RFP-CSP #1006-26 – TOMBALL HS MULTI-PROGRAM ACTIVITY CENTER

Addendum No. 01

Addendum No:	01	**Issue Date:**	11/06/2026
Project:	Tomball HS - MPAC	**To Drawings + Specifications dated**	10/30/
Prepared By:	PBK Architects, Inc. 11 Greenway Plaza, 22nd Floor Houston, Texas 77046		
PBK Project No:	25046901

A620 - WALL SECTIONS - AREA B

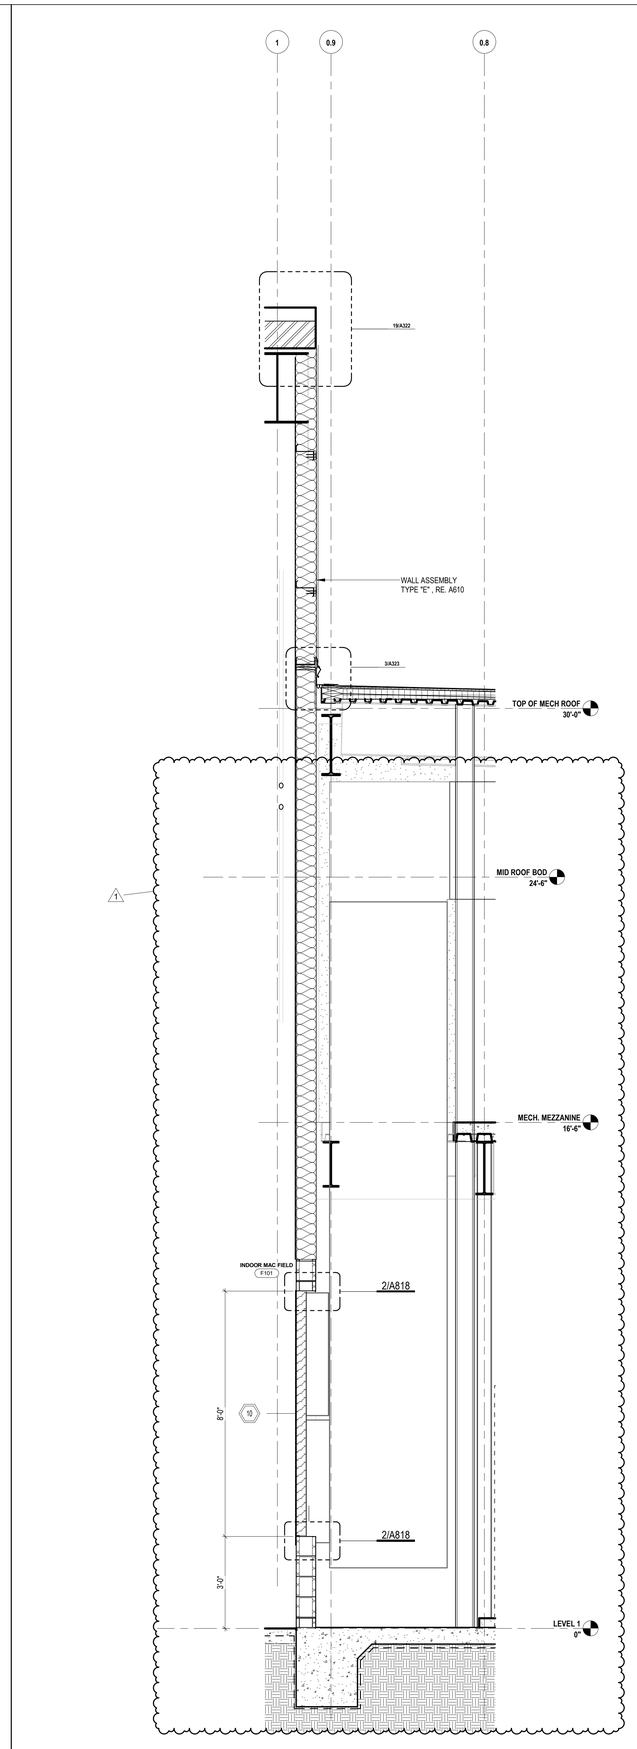
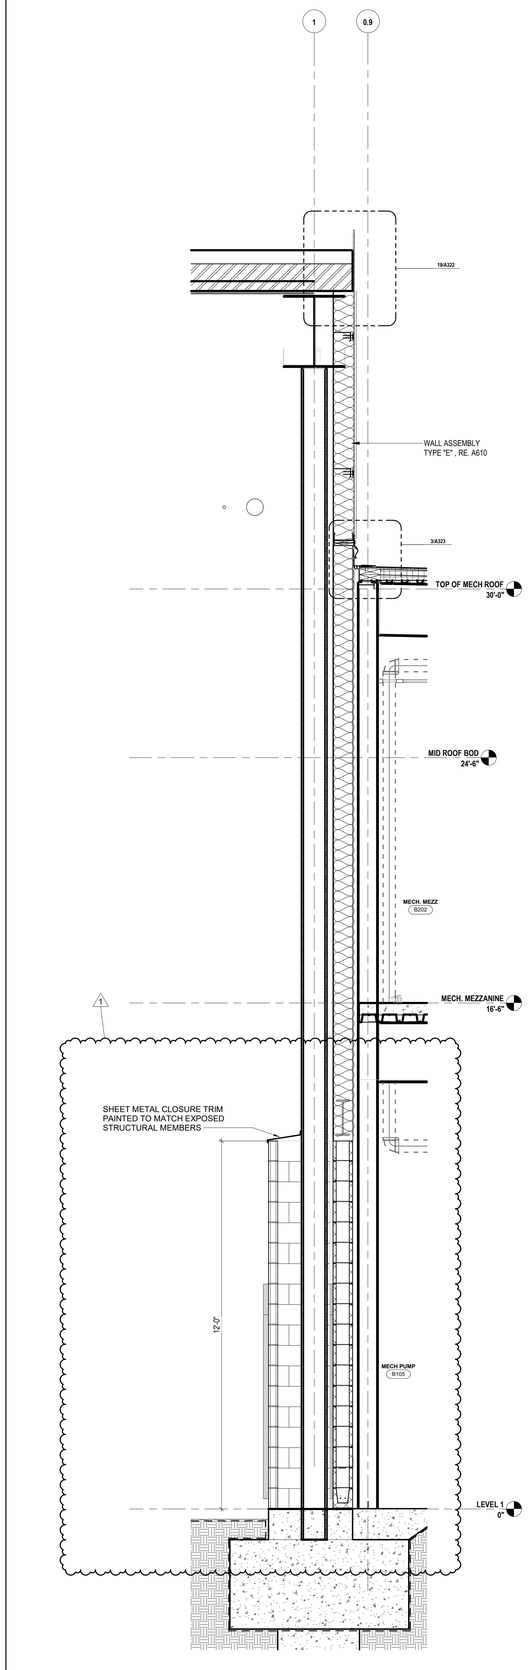
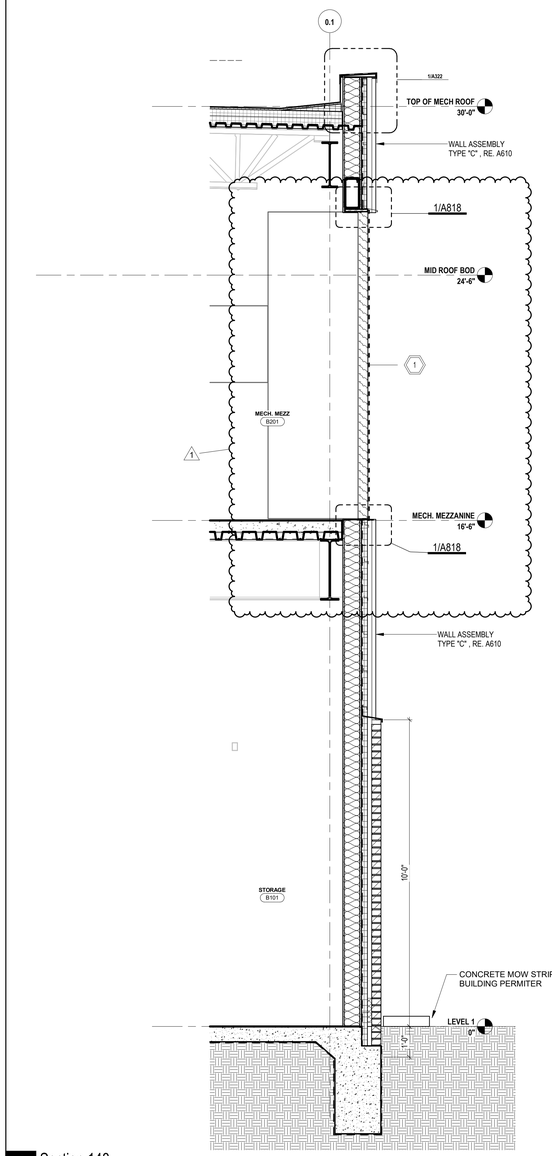
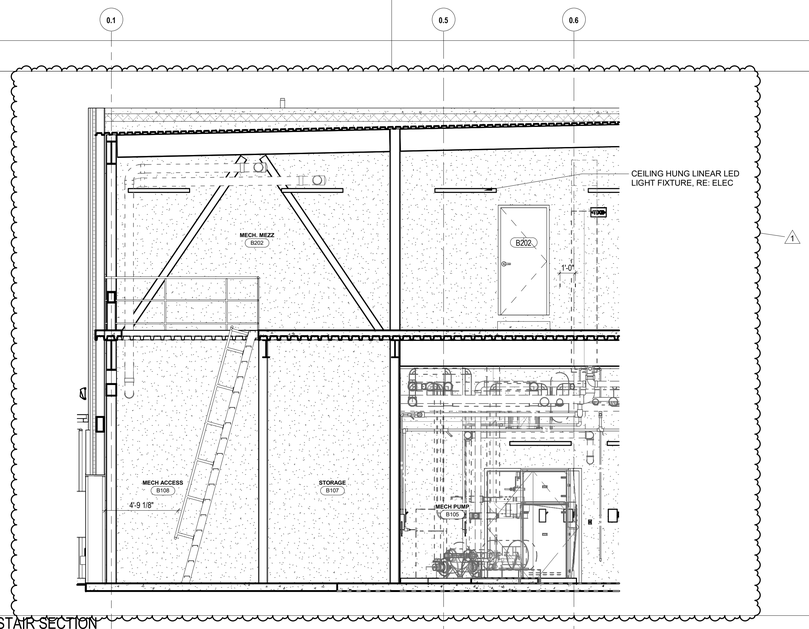
Item No. 19 **Sheet A620 WALL SECTIONS AREA B :**

b. MEP color removed for clarity. Parapet detail callouts added, Dimensions added to masonry walls. Louver detail callouts added.

A633 - STAIR PLAN AND DETAILS

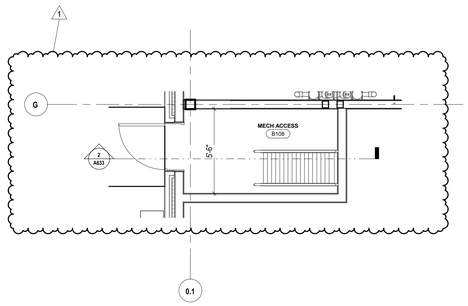
Item No. 20 **Sheet A633 STAIR PLANS AND DETAILS :**

c. Stair railing adjusted to sit at mezzanine level. Color removed from MEP model for clarity. Step Added infront of roof access door with raised sill, section reference shown on adjacent plan. .
